On ACT peak-to-peak voltage levels

Ragnar Jonsson and Saket Sakunia - Infineon
January 14, 2026

IEEE 802.3dm Task Force

PoC and AC-coupling Circuit

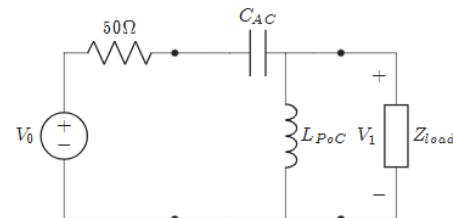
- For 802.3dm signaling the primary source of increased Crest Factor is the PoC circuitry on the PCB
- The Transfer function for the circuit on the right is

- The derivation of this transfer function and the corresponding discrete transfer function is shown on slide 8
- These transfer functions can be used to evaluate the Crest Factor of the transmit signal at the MDI
- Such evaluation shows that the Crest Factor is typically less than **1.7** for PAM4 signals and **1.3** for PAM2 signals

Replace values in Table 201-11 with the following

Transmit Rate	-T1 Max (V)	-V1 Max (V)
10G	1.30	0.65
5G	1.00	0.50
2.5G	0.80	0.40
